BRYAN G HALL

Project Name:	Dearne Valley Parkway, Barnsley				
Client:	Gregory Property Group (GPG)				
Subject:	Response to Barnsley Highways Consultation Comments				
BGH Reference:	20-262-004.02				
Date:	05/09/2022				
Prepared by:	R. Donaldson	Checked by:	A. Bradley	Overview by:	M. Crabtree

Responses to BMBC August 2022 Consultation Comments

Drawing No: 20/262/TR/001

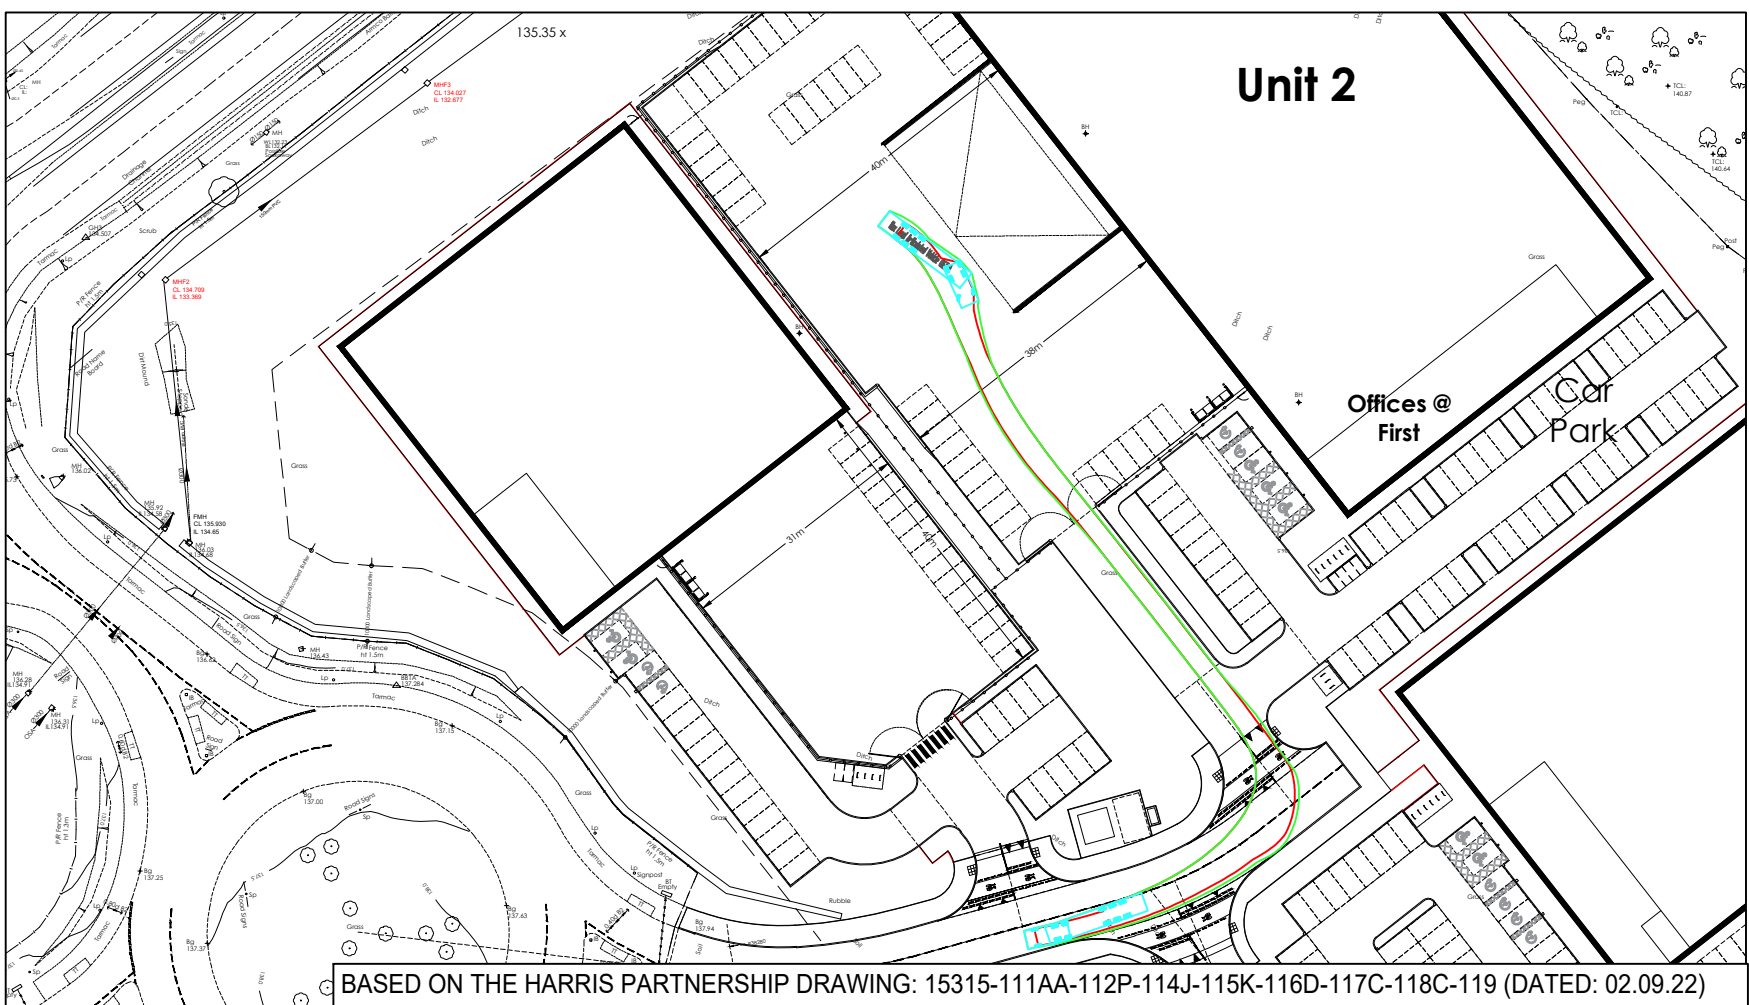
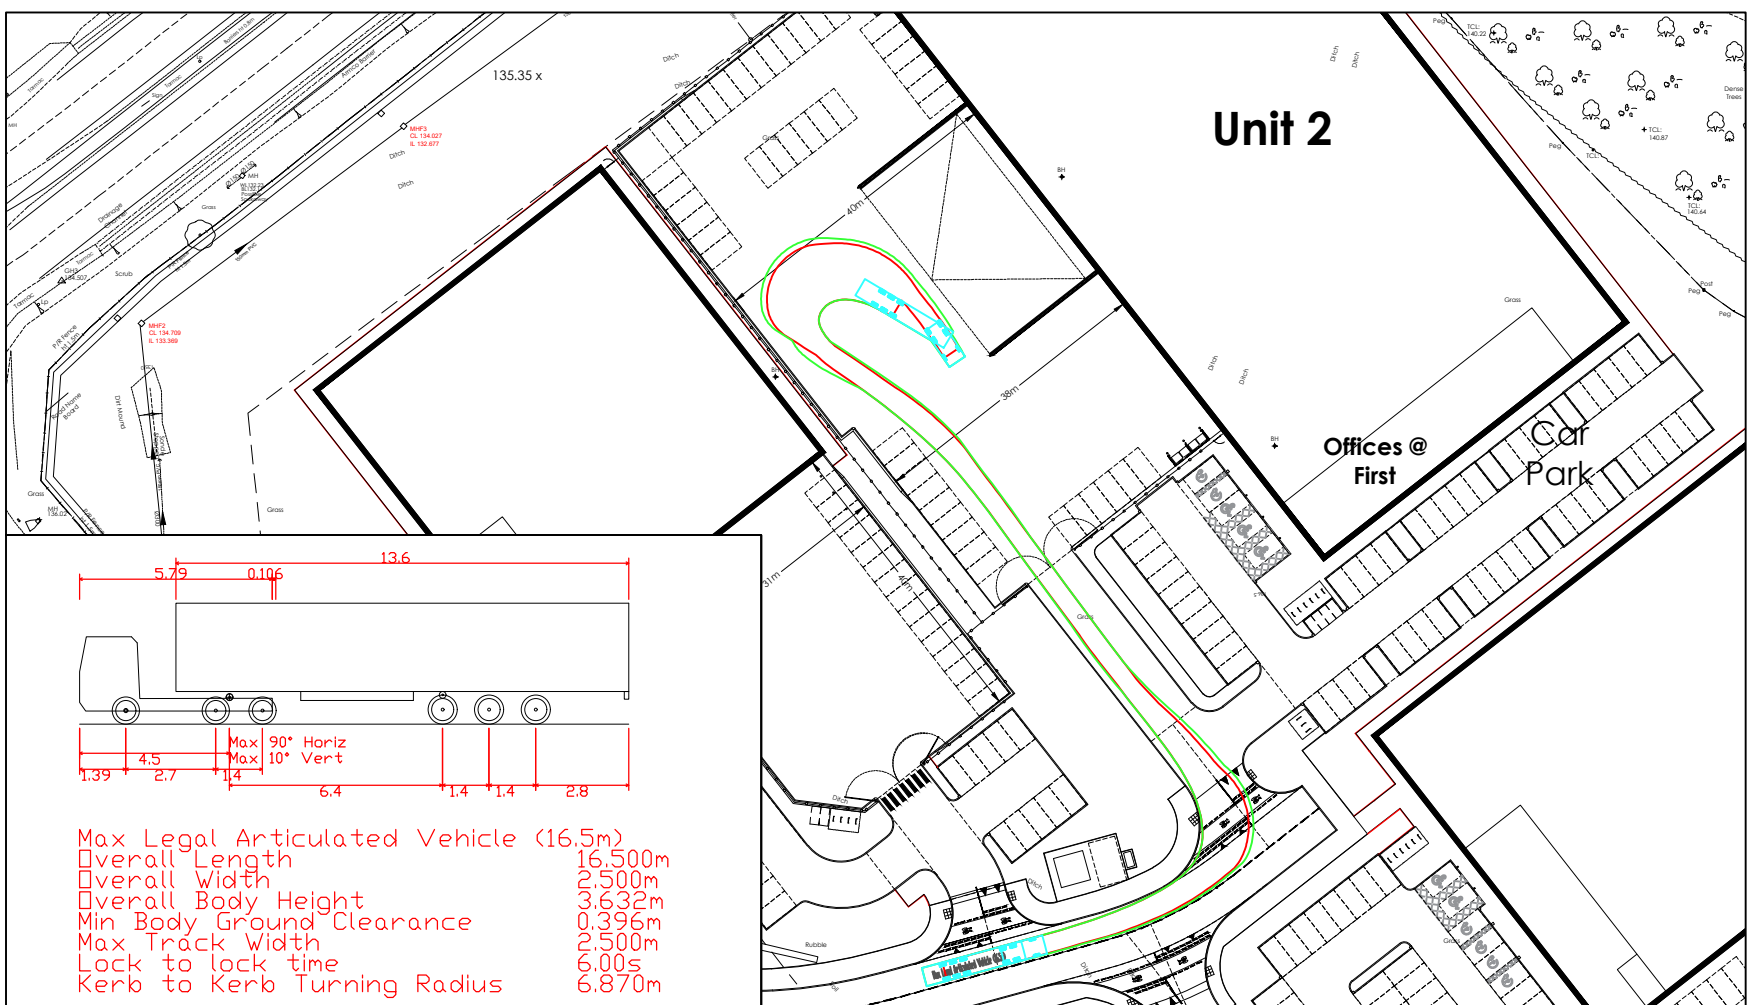
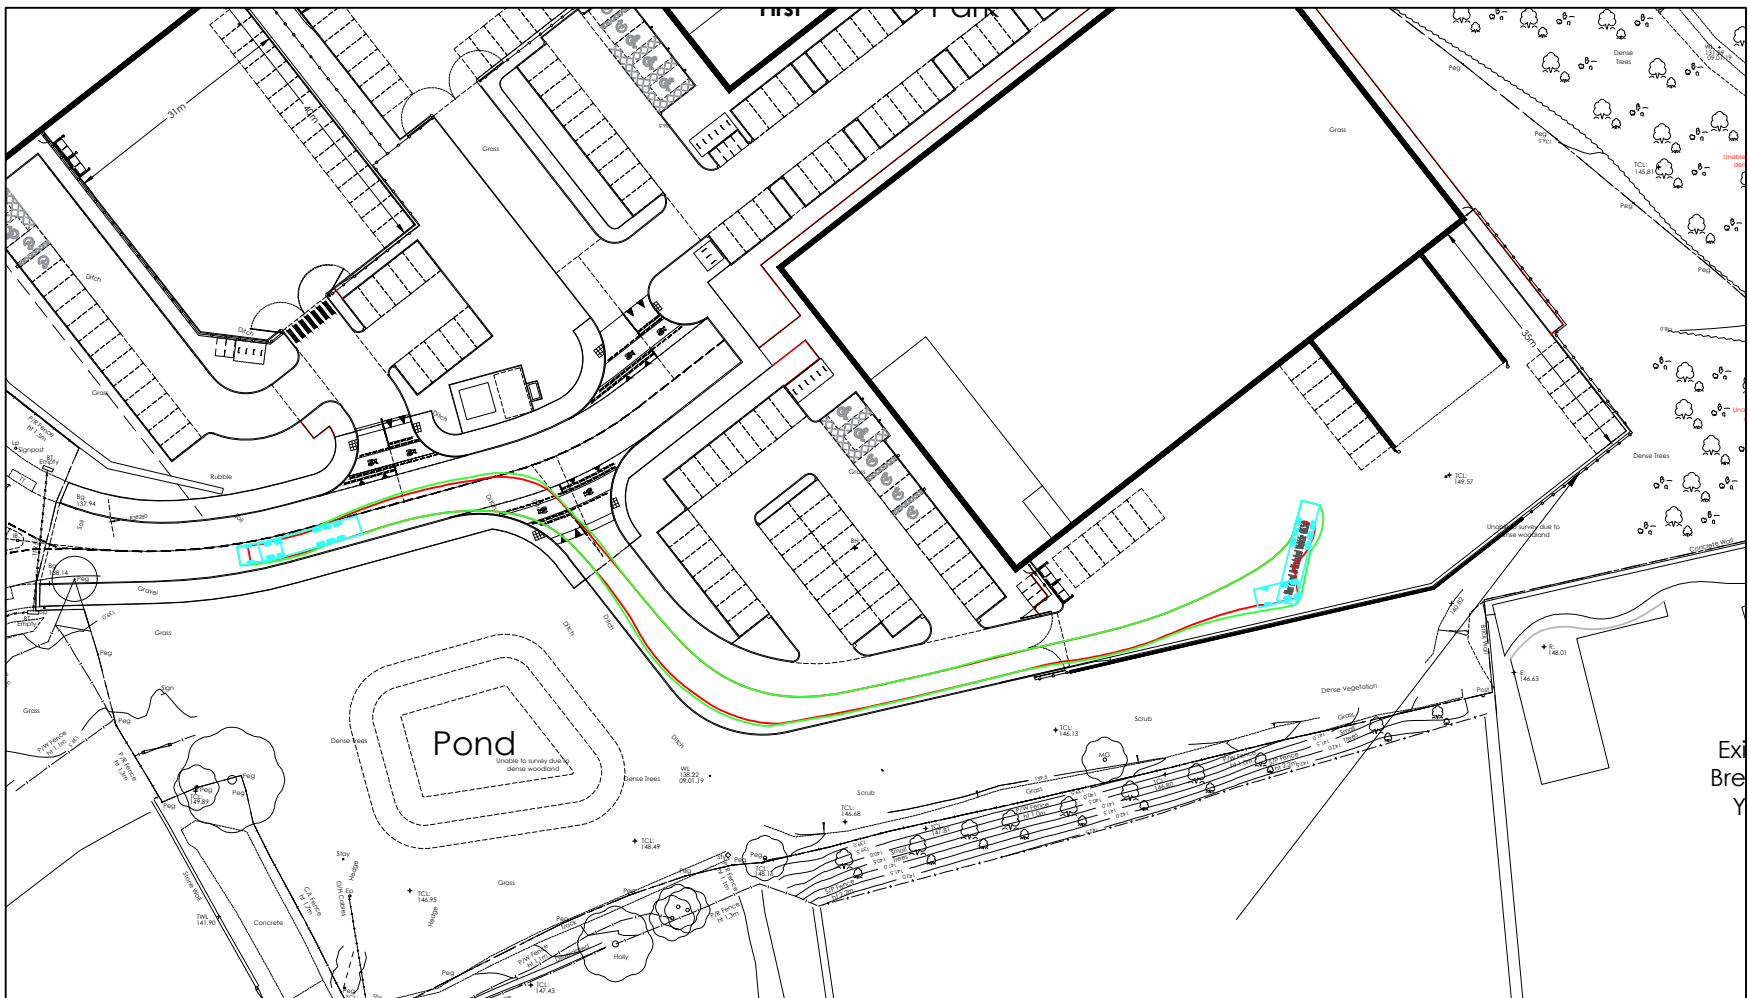
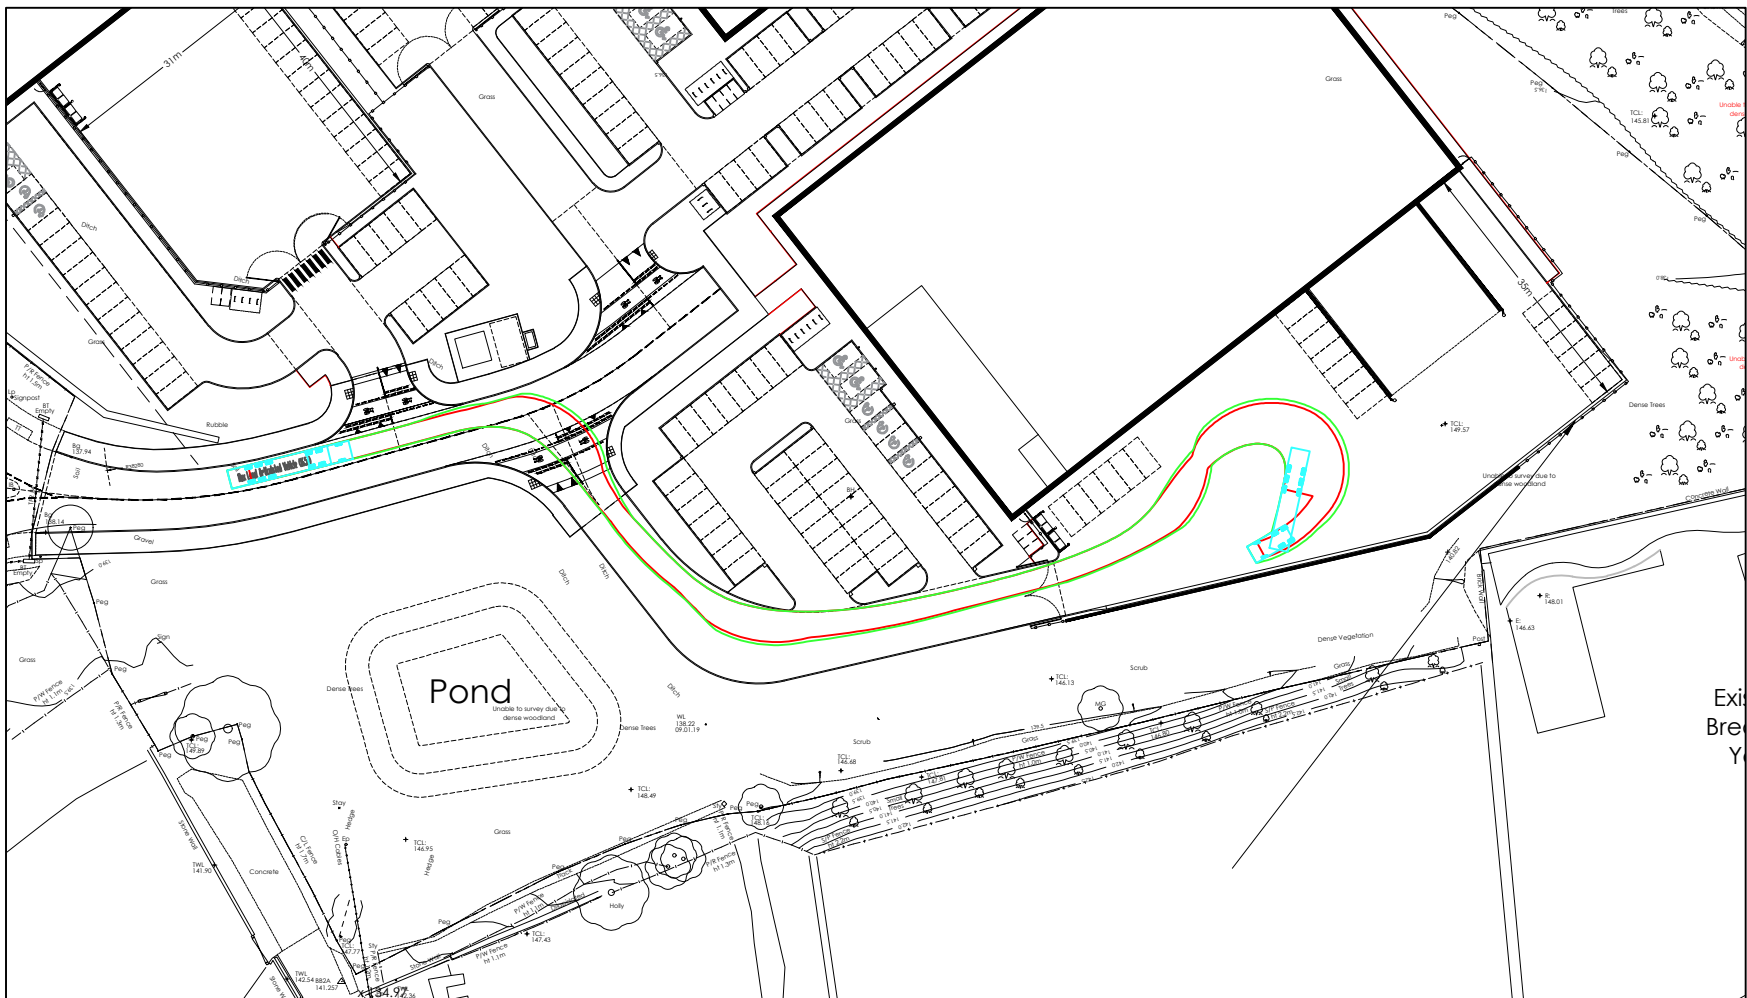
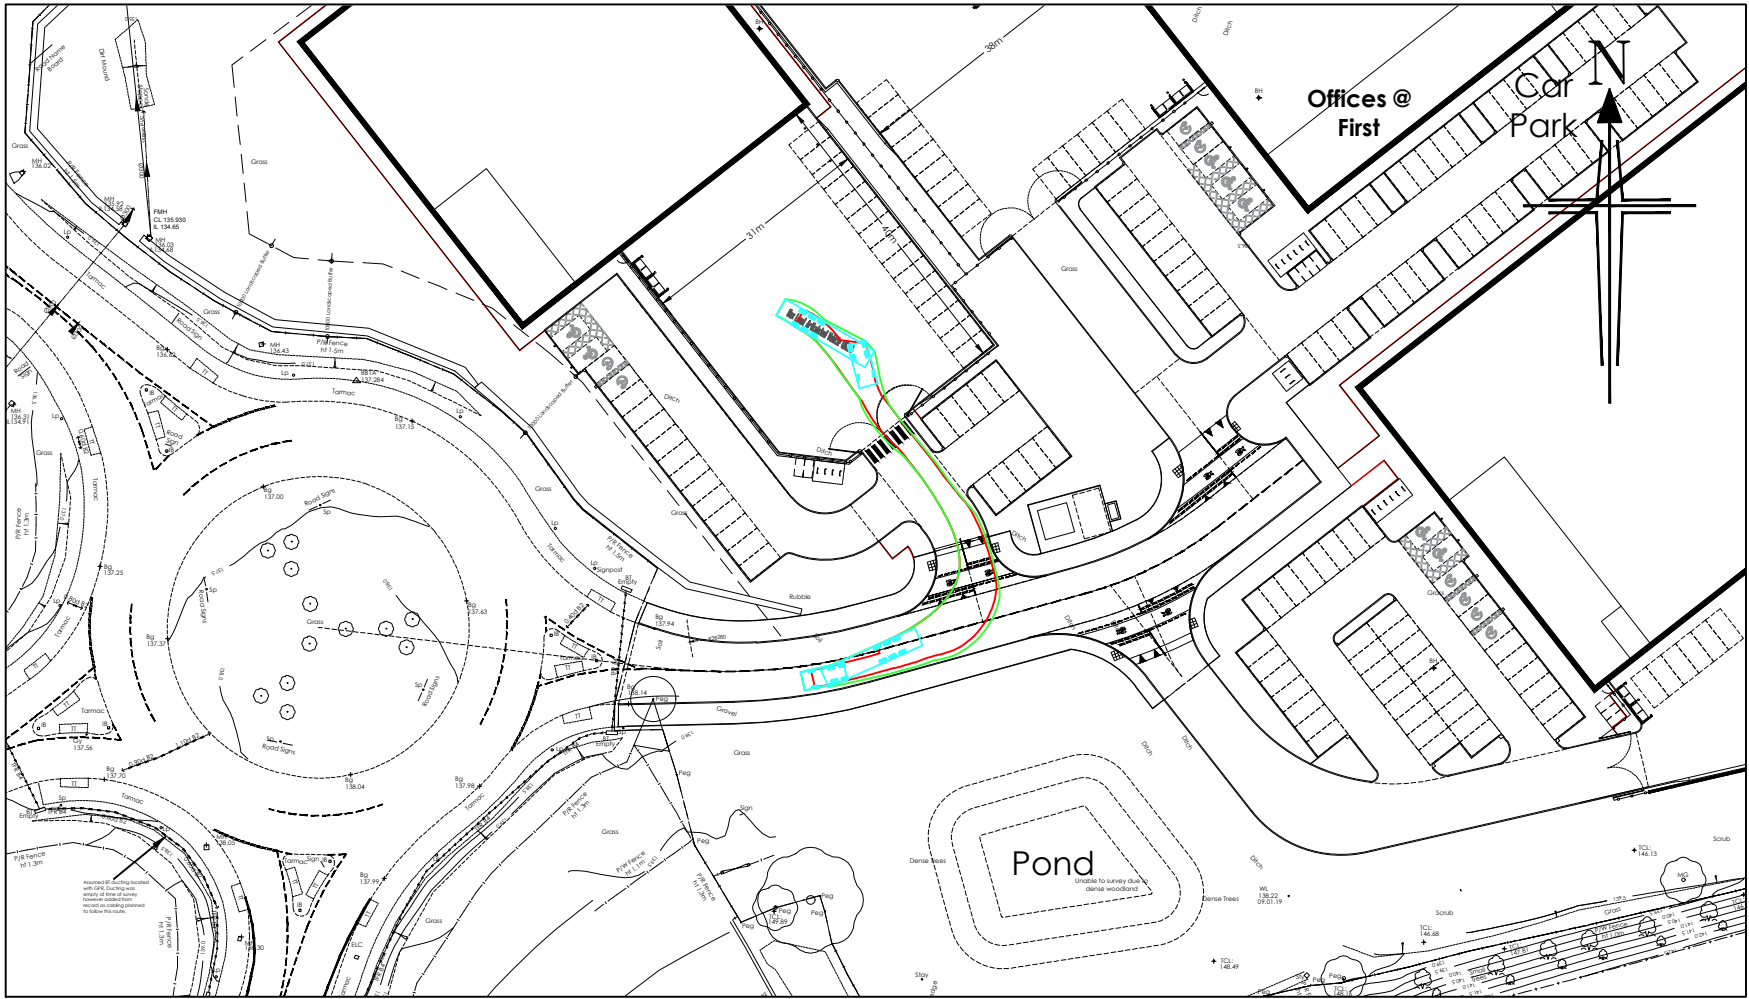
"The Transport Assessment appendix BGH 9 provides swept path analysis but will not be acceptable. A revised swept path analysis will be required that shows 2 x 16.5m articulated HGVs passing which should include a turning head."

7. Updated swept path analysis of the revised proposed site layout has been undertaken, which shows that a 16.5m articulated HGV can access the site and pass another HGV on the main site access road and the access road to Unit 3. The swept path analysis has been undertaken based on the proposed site layout with additional parking in the service yards, to demonstrate that there is sufficient room in the service yards for HGVs to manoeuvre with the additional parking in place. This is included at **Appendix BGH3** and can be summarised as follows:

- 20/262/TR/001 Rev C – swept path analysis of a 16.5m articulated HGV accessing and egressing the site using the existing roundabout junction with Sheffield Road;
- 20/262/TR/002 Rev C – shows that 16.5m articulated HGVs can access and egress each of the proposed plots;
- 20/262/TR/003 Rev B – shows that two 16.5m articulated HGVs can pass on the proposed Unit 3 access road;
- 20/262/TR/004 Rev B – shows that a 16.5m articulated HGV can manoeuvre within the proposed Unit 3 service yard;
- 20/262/TR/005 Rev B – shows that a 16.5m articulated HGV can manoeuvre within the proposed Unit 2 service yard;
- 20/262/TR/006 Rev B – shows that a 16.5m articulated HGV can manoeuvre within the proposed Unit 1 service yard; and
- 20/262/TR/007 Rev A – shows that two 16.5m articulated HGVs can pass each other on the main access road through the site.
